REQUEST

Current Zoning: O-1(CD) (office, conditional)
Proposed Zoning: UR-2(CD) (urban residential, conditional)

Approximately 13.17 acres located on the east side of the intersection of Yorkmont Road and Parkway Plaza Boulevard.
(Council District 3 - Mayfield)

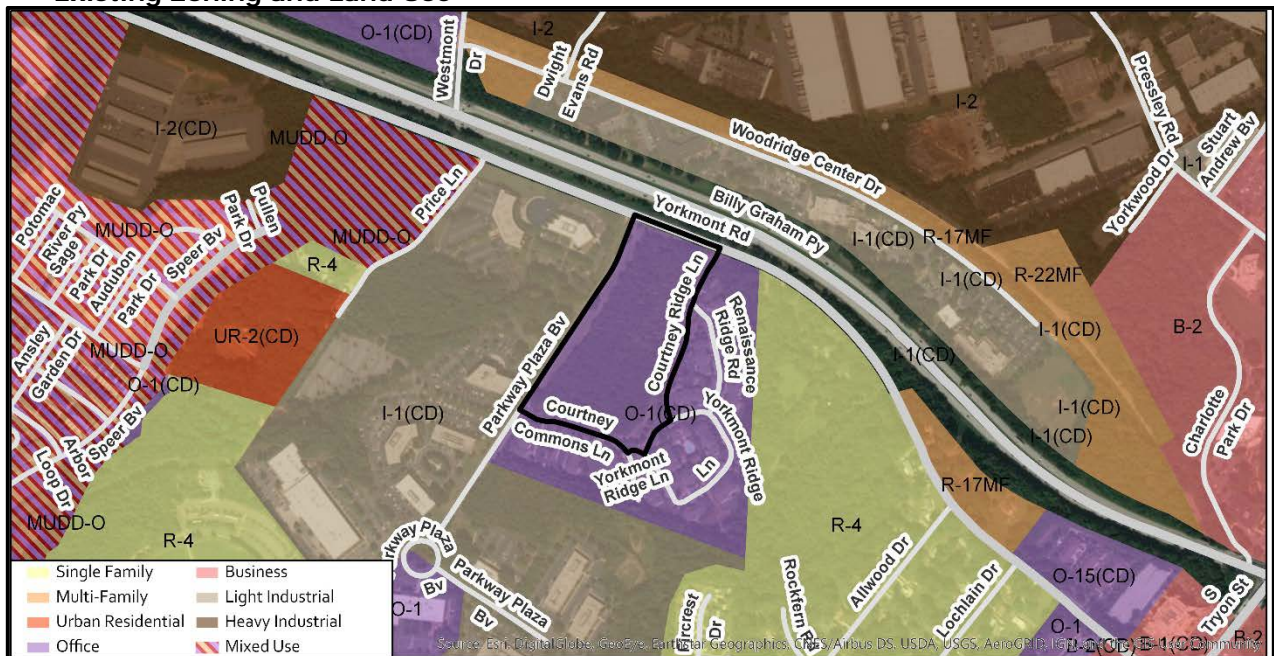
1. ~~Yorkmont Road The location of the future back-of-curb is 19 feet from the centerline of road. Label and dimension from the centerline. Site plan shows future back-of-curb 29 feet from centerline. Update the site plan and conditional notes to show the future back-of-curb to be 19 feet from centerline as described above.~~ Addressed
2. ~~Update 4.A. to commit to installation of signage within proposed new road.~~ Addressed
